Monks Orchard Residents' Association
(MORA) Planning

11th November 2019

Complaint Ref: Complaint: CAS-73997-G6H8D7 London Borough of Croydon - Escalation to the Local Government Ombudsman, Planning Application Ref: 19/01761/FUL Pegasus 18a Fairhaven Avenue, Croydon CR0 7RX.

Table 3.2 for this development at 18a Fairhaven Ave.

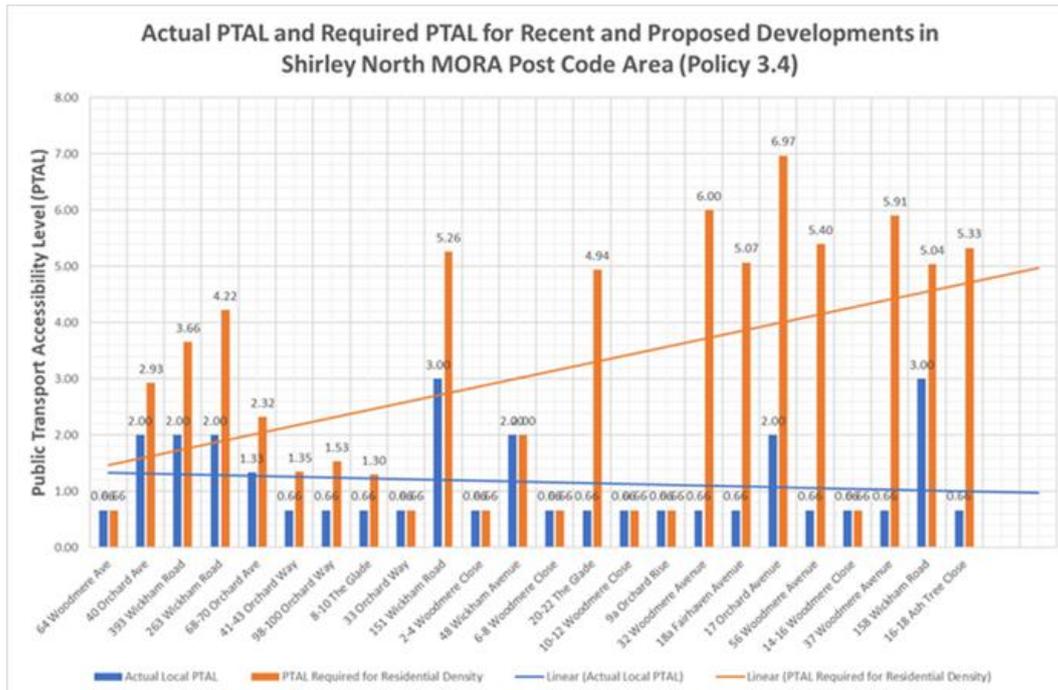
The above Histogram shows the cumulative increase in PTAL required, resultant on recent approved and proposed excessive Residential Densities, non-compliant to the London Plan Policy 3.4 (based on the proposed development Residential Density evaluation of required PTAL to support the Density in accordance with Table 3.2) and future Trends.

What **"site specific factors which are so significant"** to have given sufficient weight for this proposal at the lowest **Public Transport Accessibility Level (PTAL) of 1a** at recommended **Residential Density** in the broad range of **150 to 200hr/ha** to allow a **Residential Density** of **280.11hr/ha** which requires a **PTAL of 5.07** – in the highest range possible, or a **Housing Density** at **PTAL 1a** with recommended range of **40 to 65u/ha** to be actually at **84.03u/ha** requiring a **PTAL of 4.97** – again in the highest range **4 to 6**?

The locations Public Transport Infrastructure could not support the proposed development's Residential Density as measured by habitable rooms per hectare (hr/ha) was too high for the available and forecast public transport accessibility for future occupants of the development in accordance with the Policy and by definition **should have been resisted**.

Figure 2.29e: Requirements for entrances and boundary treatments.

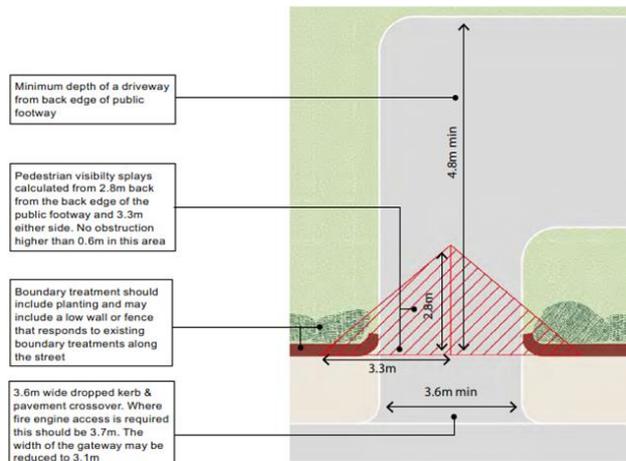
However, **this illustration** is for a **single dwelling drive** and for drive to a **hardstanding** – **NOT** an access drive for a small **backland estate development of 9 Timber Frame dwellings**. The issue relating to access is predicated by the need for ease of emergency vehicle(s) access from the Fire and Ambulance emergency services – especially when considering the likelihood of Timber Frame construction of the proposed development.

This existing width would be acceptable for a single family dwelling’s occasional entrance and exit but is **totally unacceptable** for access to a small **backland estate development** accommodating **33 occupants** and **9 cars** and to provide access for the various delivery vehicles to the **9 dwellings**, lorries for building construction and materials and removal Pantechnicons for furniture and white goods delivery when new occupants move in to the new dwellings. The Drive Access width as required by **SPD2 Section 2.29** is **3.6m minimum** with a **3.3m visibility splay** from the centre of the drive to either side for safety of pedestrians (See fig 29e). The adjacent wall RHS view toward the drive is greater than 0.6m. This proposal with drive width of **2.83m** does **NOT** meet this SPD2 requirement and **should therefore have been refused**.

In order to provide **access** for standard pump Fire Appliances a minimum unobstructed **road width** of **3.5 metres** is required to give **access**, to within **70 metres** of the allotment centroid and **90 metres** to the nearest fire hydrant.

The Chaffinch Brook Alleviation Study Catchment Area marked in Red.

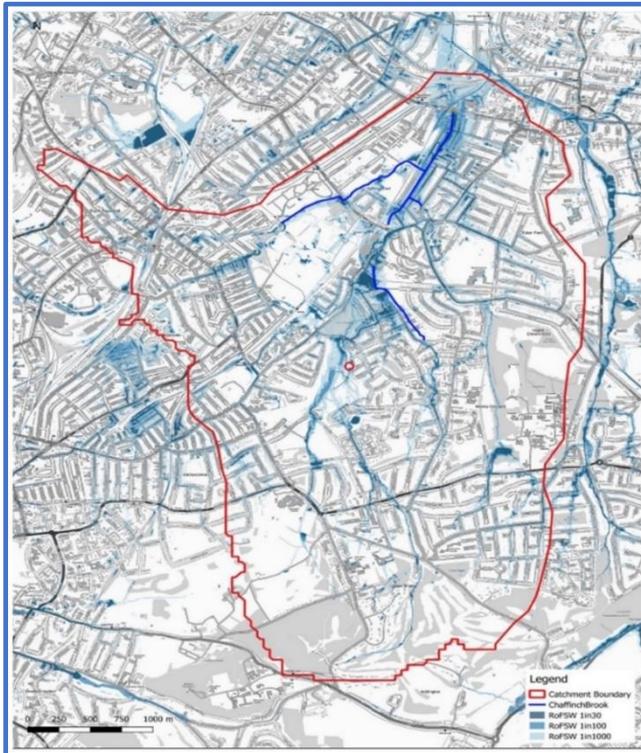
Complaint #3 The lack of consideration of contribution to Flood Risk into the Chaffinch Brook or to obtain advice from the Chaffinch Brook “Flood Alleviation Study” (FAS) to verify whether the proposal would contribute to increased risk of local flooding and contribute to the Chaffinch Brook culvert and flood risk toward Bywood Avenue.

predominantly of London Clay is simply not a good enough reason to have ignored the study. It may be that you are not required to engage with the Chaffinch Brook Alleviation Study but as the Council are part funding this study and it is very relevant to this proposal, it seems eminently sensible to have done so as the proposed development could contribute to potential additional surface water flooding in this locality.
